STATE OF CONNECTICUT
CONNECTICUT SITING COUNCIL

DOCKET NO. 445

**HOMELAND TOWERS, LLC and NEW CINGULAR WIRELESS, PCS LLC (AT&T)
RESPONSES TO CONNECTICUT SITING COUNCIL QUESTIONS SET TWO**

Bog Turtle Conservation Zone Map

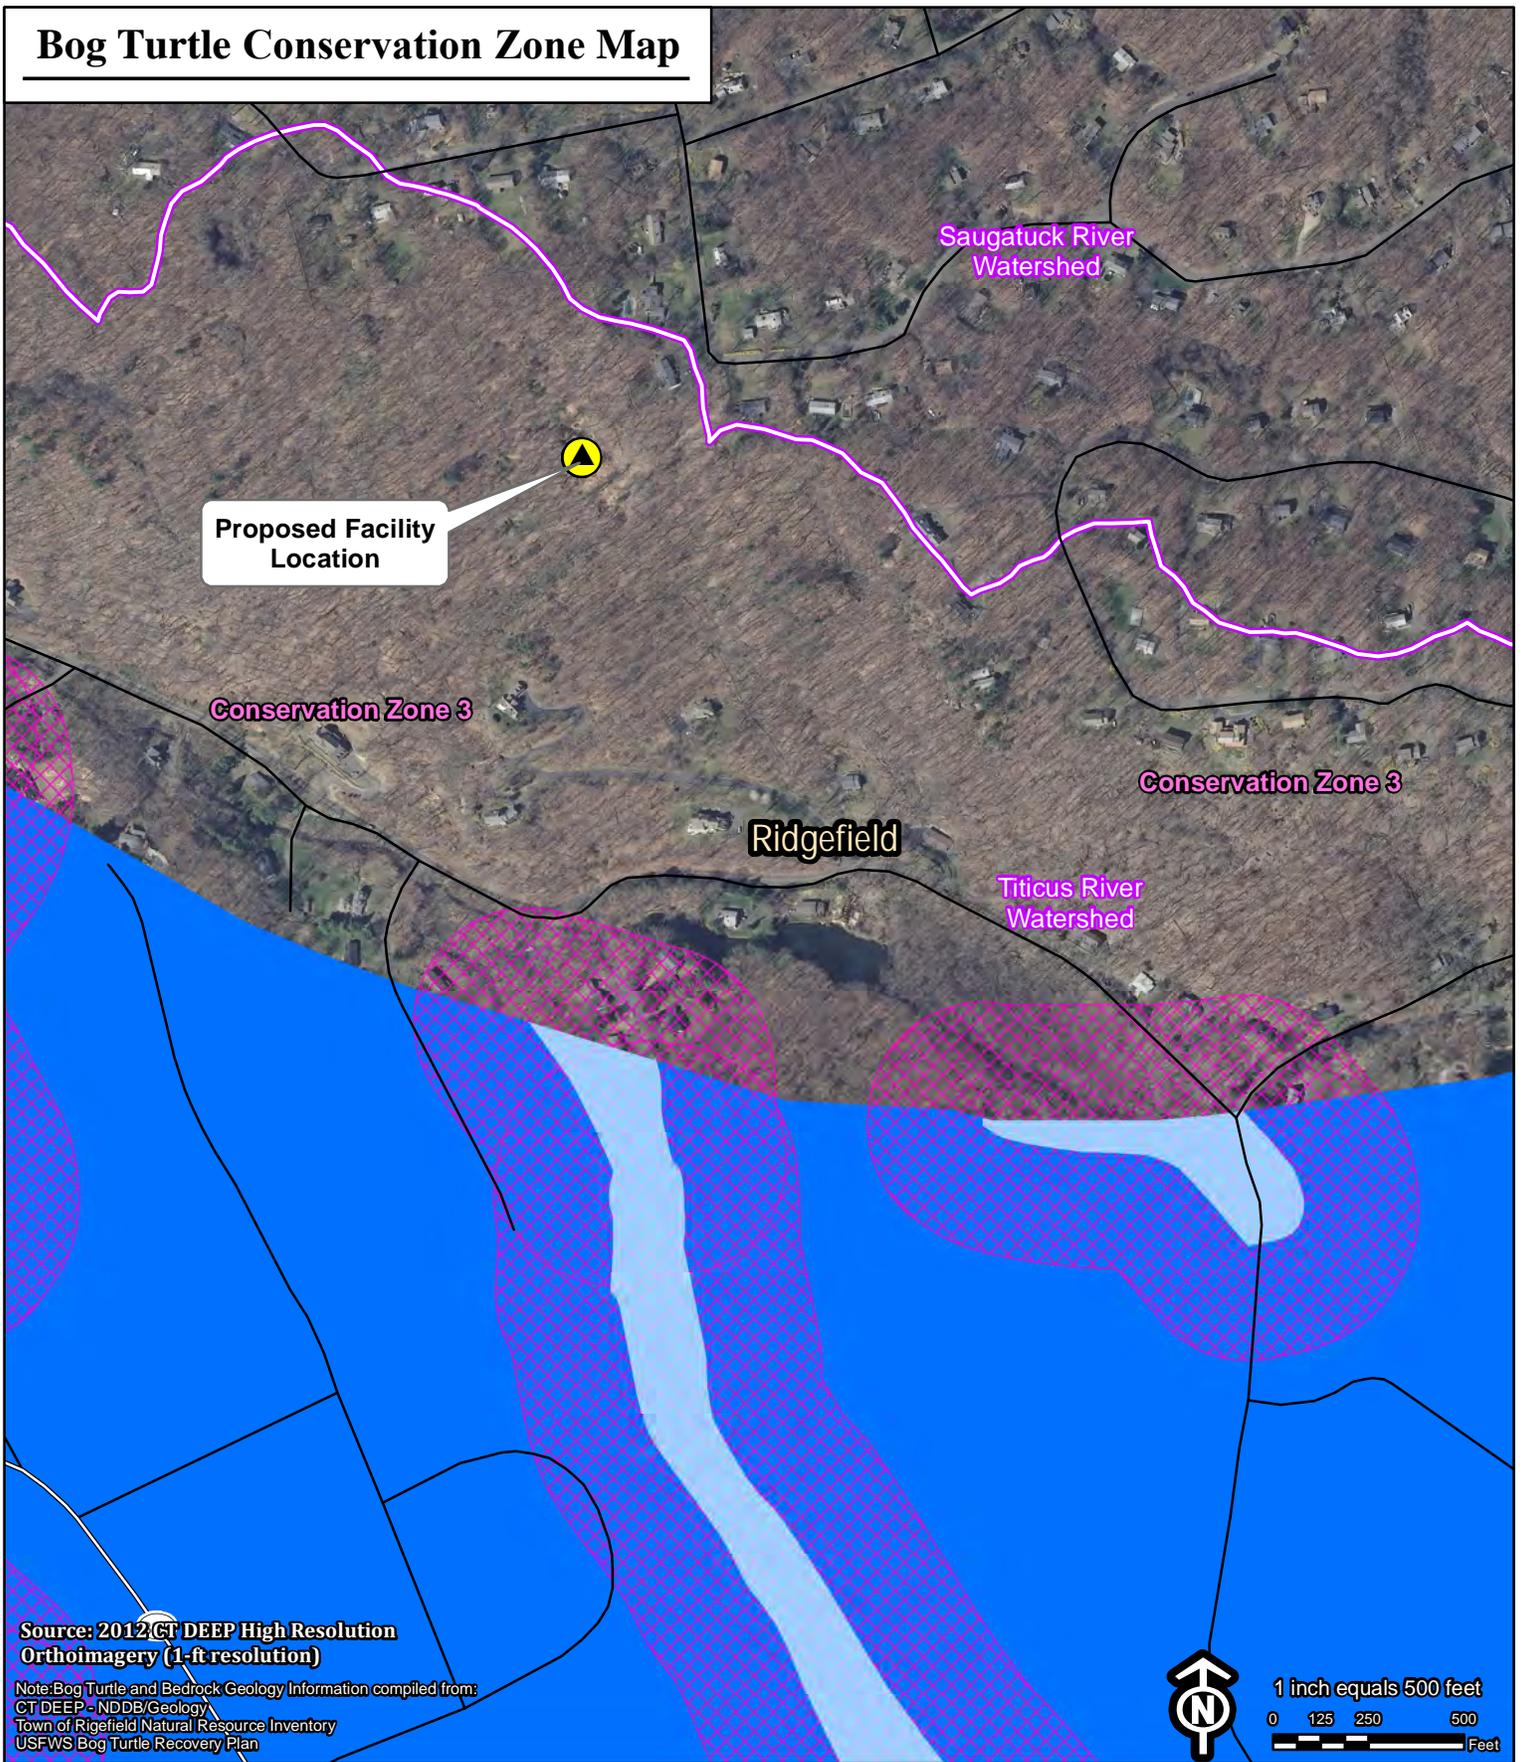
- Q28. The Recovery Plan lists three zones of management concern for the Bog Turtle. Please identify the management zone in which the proposed tower site lies.

- Q29. Reviewing the criteria for minimizing impact to bog turtles and their habitat within the appropriate management zone, please describe in detail how the proposed activities comply or do not comply with each criteria or recommendation of the appropriate zone within the Recovery Plan.

The subject property is underlain by Manhattan Schist, an acidic dark-gray to silvery, rusty-weathering, generally coarse grained, foliated but poorly layered to massive gneiss or schistose gneiss, composed of quartz, oligoclase, microcline, biotite, and muscovite, and generally sillimanite and garnet.⁵ Areas of bedrock outcrops located on and surrounding the site were field identified as schist. Refer to Photo 6 in the enclosed Photo Documentation. Therefore, the forested wetland seep located on the subject property would not be considered Zone 1. As described in the response to Question 26, which identifies the location of nearby bog turtle habitat, the conservation zone in which the proposed tower site lies is classified as Zone 3. Please refer to the attached Bog Turtle Conservation Zone Map.

- A29. *Within conservation Zone 3, the focus on avoiding impact to bog turtle habitat is associated primarily with hydraulic alternations to wetland areas and water quality (e.g., via nutrient loading, sedimentation, and contaminants).⁶ Proposed development of the access road and tower compound will not alter existing drainage patterns and both stormwater quantity and quality will be properly treated.⁷ In addition, an Eastern Box Turtle and Wetland Protection Program will be implemented during construction to provide additional water quality protection during construction.⁸ This protection program was reviewed by DEEP Wildlife Division and found to be protective of bog turtle habitat.¹ Therefore, the proposed Homeland Towers development complies with the conservation recommendations in Zone 3.*
